INSPECTION REPORT
Sedimentation Structure
N5-D
Black Mesa Mine
Navajo County, Arizona
for
PEABODY COAL COMPANY

Dames & Moore
10139-011-22

SITE PLAN
N5-D

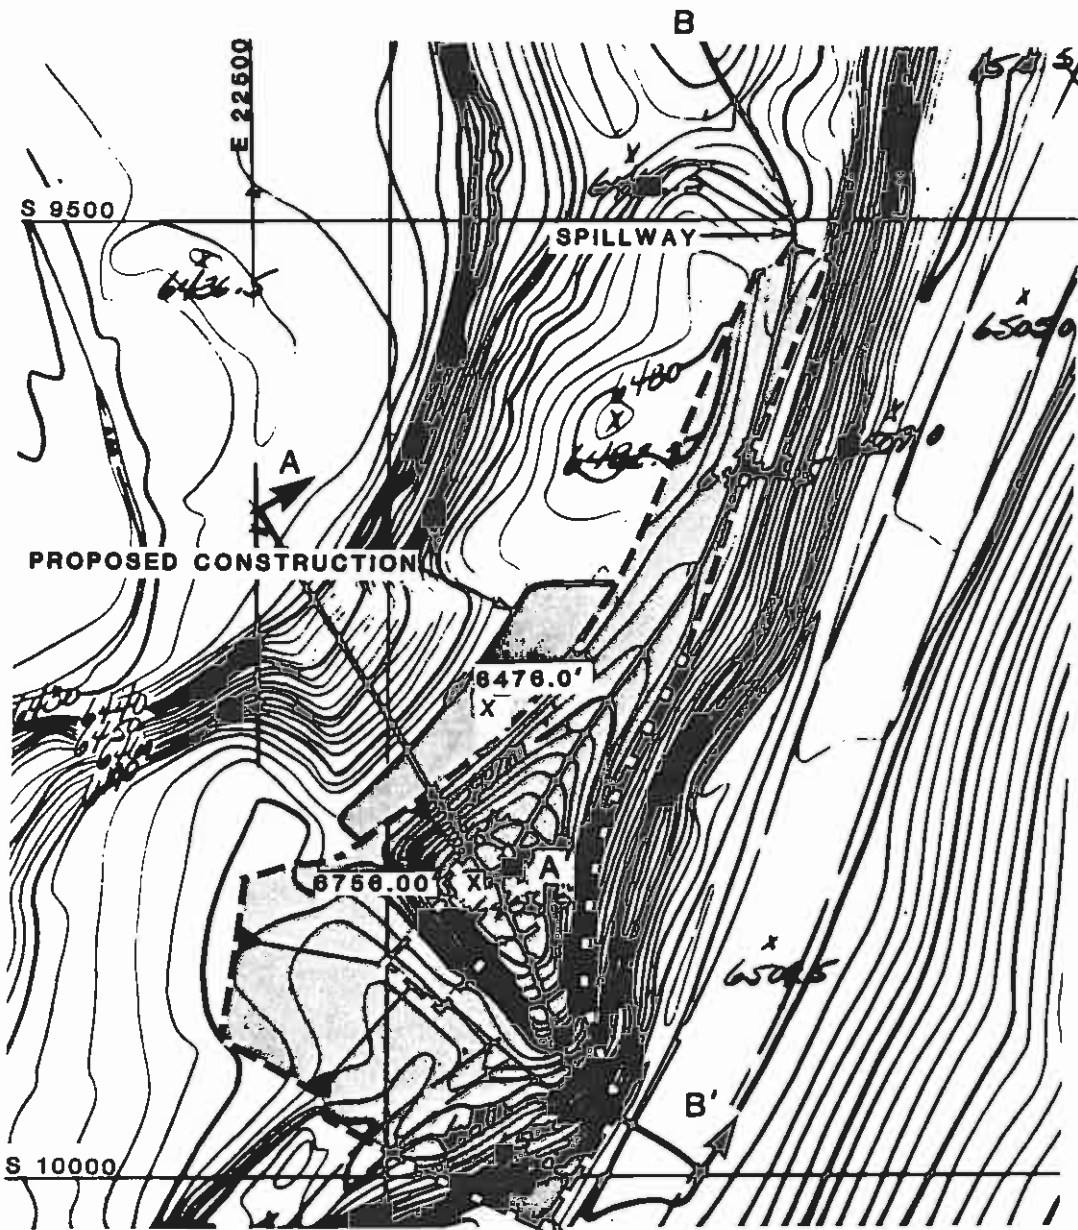
The spillway capacity and storage capacity of Structure N5-D are inadequate. The structure does not have an adequate outflow channel. The storage capacity should be increased to 5.36 acre-feet by excavating the pond and lowering the spillway elevations as shown on Plates 1 and 4. The embankment crest should be raised to elevation 6476.00 feet. A trapezoidal outflow channel should be constructed along the alignment shown in Plate 1. The channel profile is shown in Plate 4 and the required dimensions are shown in Plate 5. Both the spillway and outflow channel should be protected against erosion using geotextile and riprap as shown in Plate 5.

LIMITS OF PROPOSED EXCAVATION

EXISTING
MAXIMUM CROSS-SECTION
A-A'
N5-D

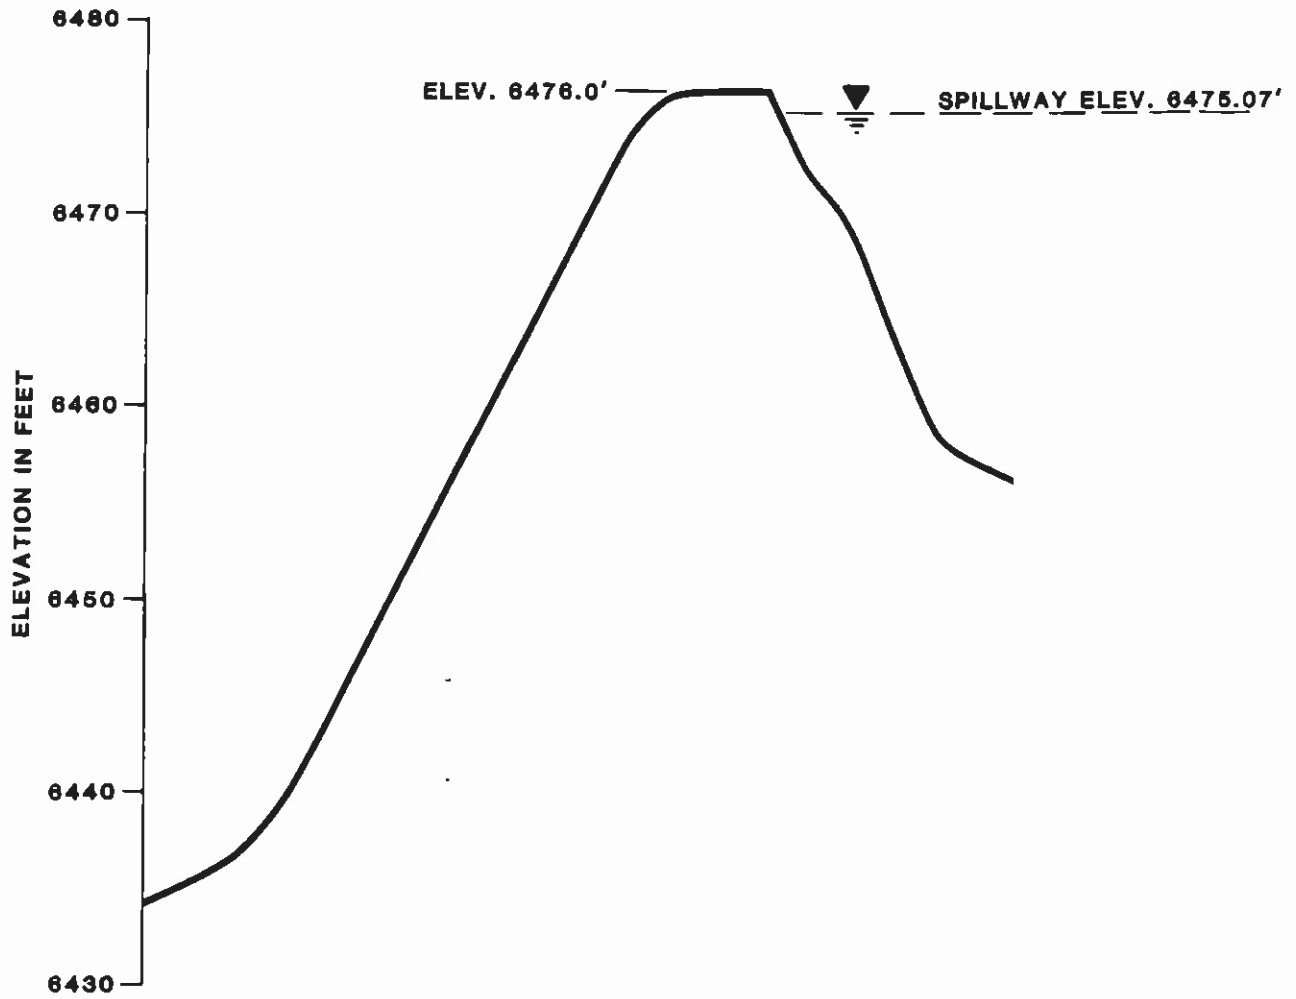
The N5-D embankment is lower in height; however, the downstream and upstream slopes are steeper than the category standard; therefore, the embankment has factors of safety less than the design minimum.

The inspection of Structure N5-D indicated that the only geotechnical problem is rill and gully erosion on the upstream and downstream slopes and the bottom of the approach channel. Correction of erosion is considered a periodic maintenance task and does not require remedial action. The downstream and upstream slopes should be flattened to 2.0 horizontal to 1 vertical and 2.5 horizontal to 1 vertical, respectively, to meet stability requirements.
